HONEYWELL  
ALBUQUERQUE, NM

#### SITE PLAN

SHEET #  
C1.0

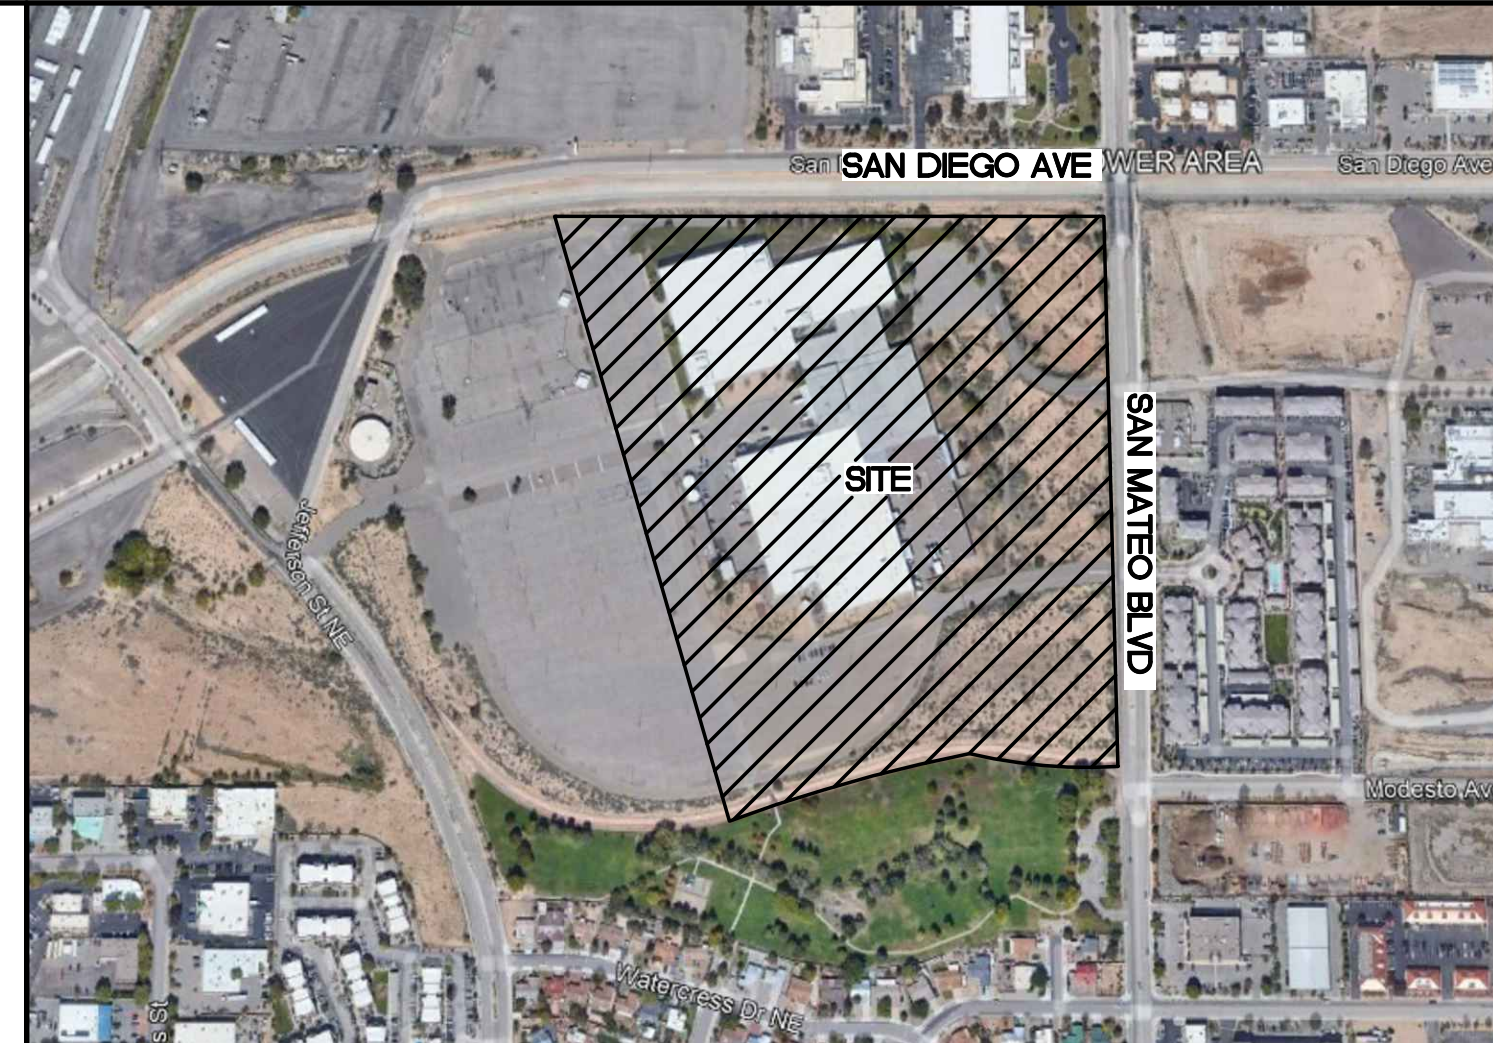
Approved for access by the Solid Waste Department.  
All containers must be made accessible for pick up  
between the hours of 5AM and 8PM.  
Reviewer: *Human Services*  
Date: 06-25-24  
\*Existing contractors\*\*  
Gates opened 24/7\*\*
